Access Compliance Report

Public Rights-of-Way

(Curb Ramps)

Intersection ID: 31534	Main Street: ALMORA_DR	Cross Street: SUNMAN_RD	Location:	N
ADA ID: BB02DA9F150A	Ramp Type: BlendTrans1	Initial Pass/Fail: Fail	Overall Compliance: No	Severity Score: 10
Codes/Mitigation Info/Possible Solution		Field Measurements/Component Compliance

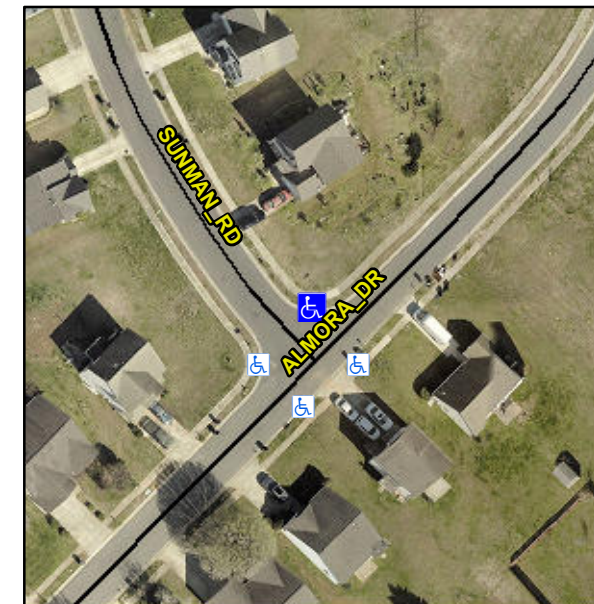
Not Found, R304.5.1, R304.5.3

Compliance	Description	Data	Compliance	Description	Data
N/A	Ramp Length (in)	48.0	Yes	BlendTrans Slope (%)	2.0
No	Ramp Width (in)	46.0	No	BlendTrans XSlope (%)	2.6
N/A	Flare Type LT	N/A	N/A	Flare Type RT	N/A
N/A	Flare Slope LT (%)	N/A	N/A	Flare Slope RT (%)	N/A
N/A	Flare Traversable LT?	N/A	N/A	Flare Traversable RT?	N/A
N/A	Landing Length (in)	N/A	N/A	DWS Provided?	N/A
N/A	Landing Width (in)	N/A	N/A	DWS Contrast?	N/A
N/A	Landing Slope (%)	N/A	N/A	DWS Length (in)	N/A
N/A	Landing X Slope (%)	N/A	N/A	DWS Full Width?	N/A
N/A	Landing Curb? (Y/N)	N/A	N/A	DWS Offset (in)	N/A
N/A	Shared Landing?	N/A			
N/A	Gutter Ponding?	N/A	N/A	Gutter Slope (%)	N/A
N/A	Gutter Lip Ht (in)	1.5	N/A	Gutter X Slope (%)	N/A
N/A	Painted X Walk1?	No	N/A	Painted X Walk2?	No
	X Walk 1 Direction	To SW		X Walk 2 Direction	To SE
	X Walk 1 Width (in)	N/A		X Walk 2 Width (in)	N/A
	X Walk 1 Slope (%)	2.7		X Walk 2 Slope (%)	8.2
	X Walk 1 X Slope (%)	4.7		X Walk 2 X Slope (%)	1.7

N/A	Ramp inside XWalk1?	N/A	N/A	Ramp inside XWalk2?	N/A
	Road Slope (%)	4.8		Clear Space?	N/A
	Road X Slope (%)	6.5	N/A	Clear Space to XWalk (in)	N/A
N/A	Any Obstructions?	N/A	N/A	Storm Grate/Utility Hazard?	N/A
	Obstruction Type			Storm Grate/Utility Type	
		N/A			N/A
			Yes	Surface Condition? (G/P)	Good
			No	Curb Slope (%)	21.3

Remove & Replace Curb Ramp With Two New Directional Ramps or Equivalent.
